**Eaves to roof WCR07 -
adjustment of refer ends
to widen gutter**

OTH-PUR-TH-RF-SKE-A-3559

Section
at eaves

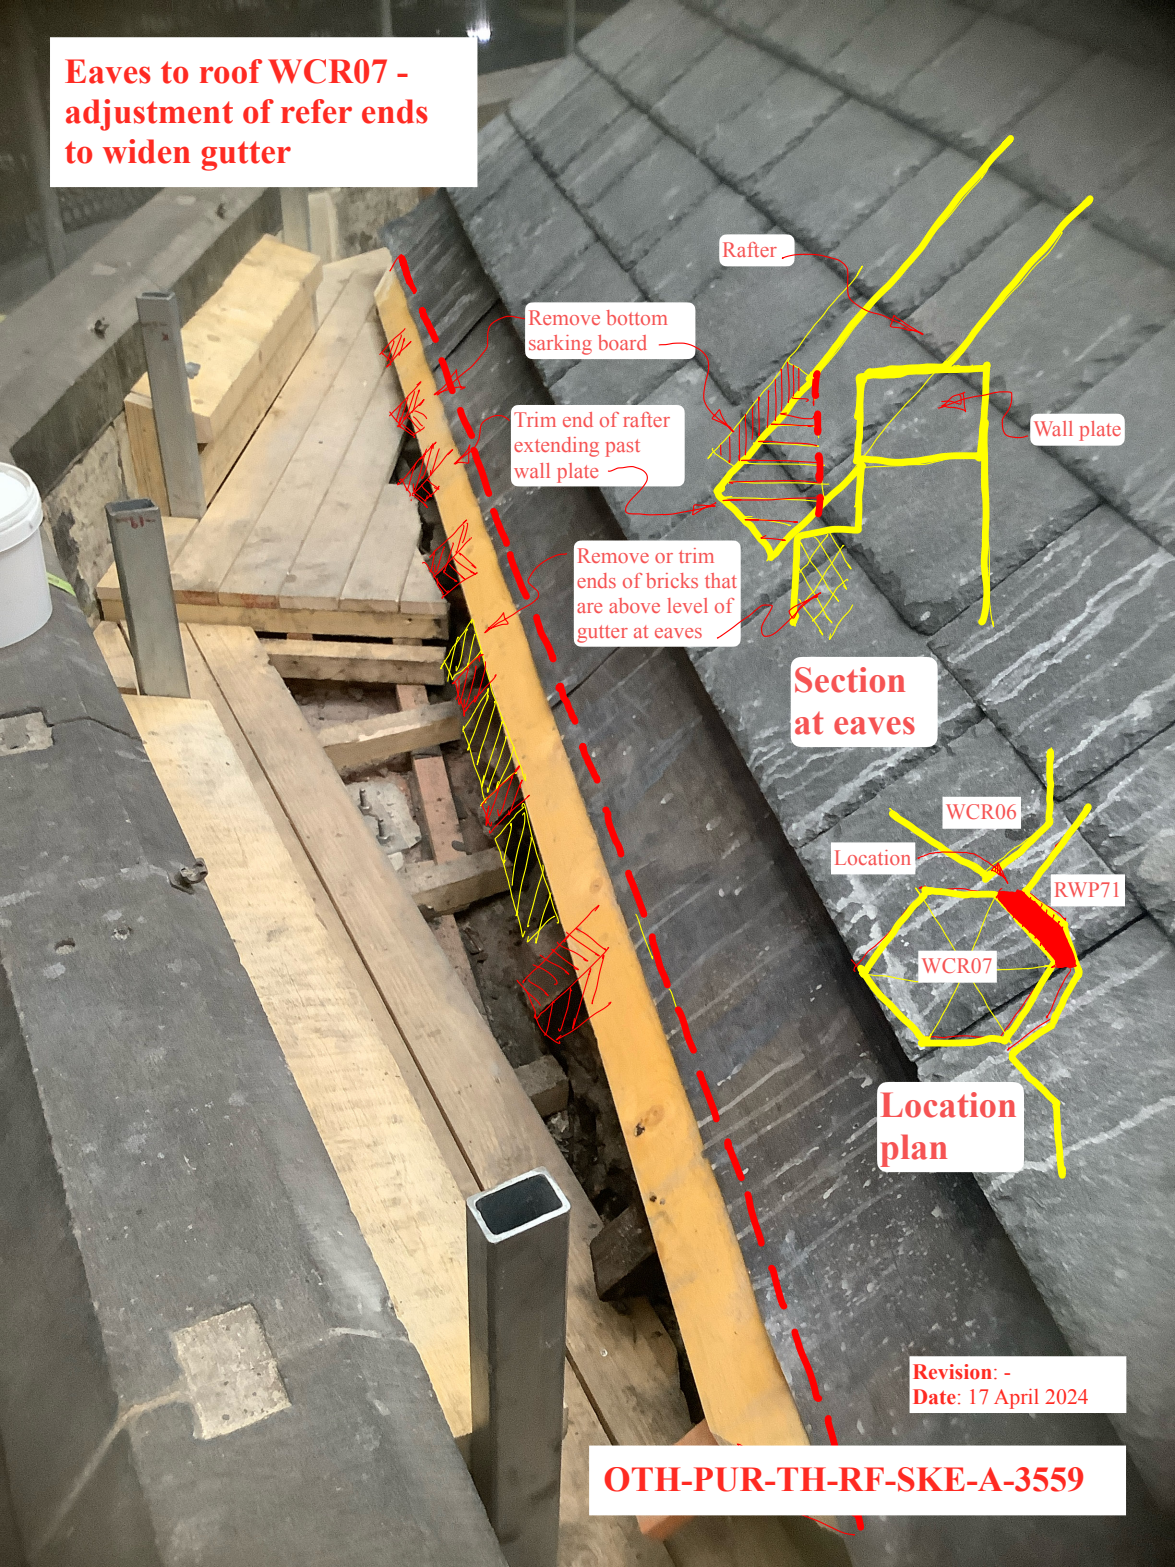
Remove bottom
sarking board

Trim end of rafter
extending past
wall plate

Remove or trim
ends of bricks that
are above level of
gutter at eaves
